CITY OF ALBUQUERQUE

Planning Department
Brennon Williams, Interim Director

**RE: Ladera Self Storage
2100 Ladera Dr. NW
Temporary C.O. - Accepted
Engineer's Certification Date: 08/02/19
Engineer's Stamp Date: 07/31/18
Hydrology File: H09D001F**

| REVISIONS | CITY OF ALBUQUERQUE |
|-----------|---|
| | DRAINAGE SIDEWALK CULVERT PLAN, AND SECTIONS A-A AND B-B DWG. 2236 MARCH 2019 |

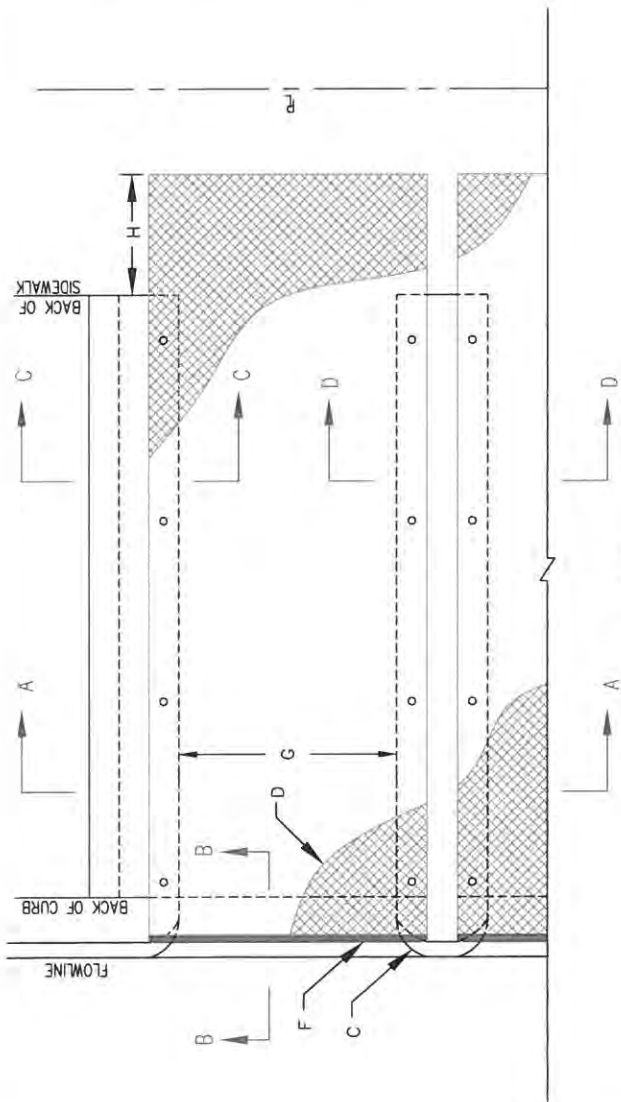
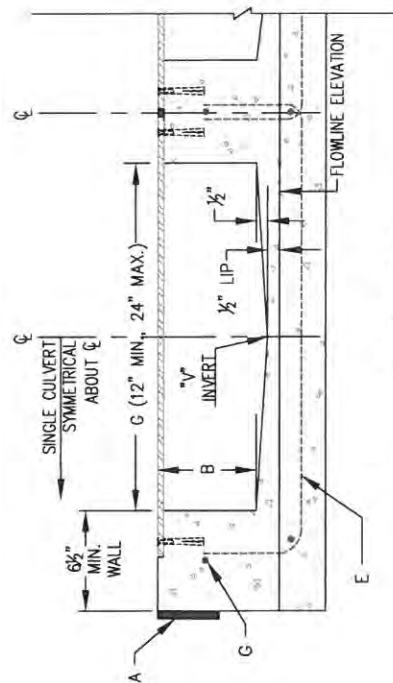
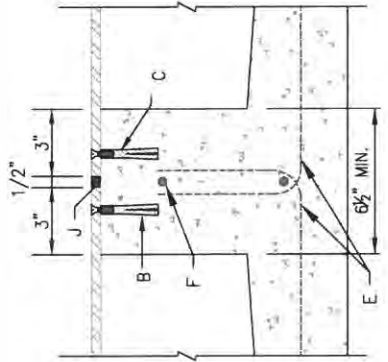
1. The sidewalk culvert on 72nd Street needs to be brought up to City standards and follow the City of Albuquerque Standard Drawing No. 2236. (See attachment) Once complete, the Contractor must contact Augie Armijo at (505) 857-8607 and Construction Coordination at 924-3416 to schedule an inspection. I will need an ok from Augie prior to issuing the Permanent C.O.
